United States Patent and Trademark Office

APPLICATION NO.	FILING DATE	FIRST NAMED INVENTOR	ATTORNEY DOCKET NO.	CONFIRMATION NO.	
10/655,595	09/05/2003	Bernd Christoph Lang	4398-254	7314	
23117 75	90 06/28/2005	EXAMINER			
	NDERHYE, PC LEBE ROAD, 11TH F	MITCHELL, TEENA KAY			
ARLINGTON,			ART UNIT	PAPER NUMBER	
			3743		
			DATE MAILED, 0600000

Application No.	Applicant(s)						
	10/655,595	LANG ET AL.						
Office Action Summary	Examiner	Art Unit						
	Teena Mitchell	3743						
The MAILING DATE of this communication app Period for Reply	ears on the cover sheet with the c	orrespondence address						
A SHORTENED STATUTORY PERIOD FOR REPLY IS SET TO EXPIRE 3 MONTH(S) FROM THE MAILING DATE OF THIS COMMUNICATION. - Extensions of time may be available under the provisions of 37 CFR 1.136(a). In no event, however, may a reply be timely filed after SIX (6) MONTHS from the mailing date of this communication. - If the period for reply specified above is less than thirty (30) days, a reply within the statutory minimum of thirty (30) days will be considered timely. - If NO period for reply is specified above, the maximum statutory period will apply and will expire SIX (6) MONTHS from the ma

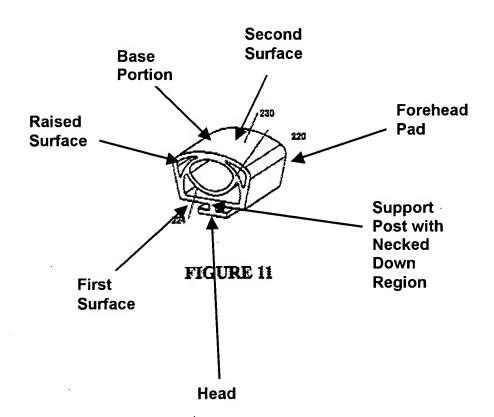
Gradon in a respiratory mask discloses: a base portion (see illustration of Fig. 11 below), wherein the base portion defines a first surface, and a second surface to contact a user's forehead, wherein the second surface is concave (see illustration of Fig. 11

below); a support post, wherein the support post projects from the first surface and comprises a necked down region; and a head adapted to connect the support post to a forehead support of a respiratory mask (Fig. 7).

With respect to claim 2, Gradon discloses wherein the support post projects from the base portion and is integrally molded therewith (See illustration of Fig. 11 above).

With respect to claim 3, Gradon discloses wherein the second surface defines a raised surface pattern to at least one of aid in airflow, prevent sweating, and increase comfort to the user (see illustration of Fig. 11 above; inasmuch as the raised surface compresses and has an opening it meets the limitations of aiding in airflow, preventing sweating and increasing comfort to a user).

With respect to claim 33, Gradon discloses a forehead support consisting essentially of a base portion to contact a user's forehead; and a support post connected to a central portion of the base portion (see illustration of Fig. 11 above, MPEP 211.03 the additional elements of Gradon do not materially effect the basic and novel characteristics of the claimed invention).

With respect to claim 34, Gradon discloses wherein the support post is substantially centrally mounted on the base portion (see illustration of Fig. 11 above).
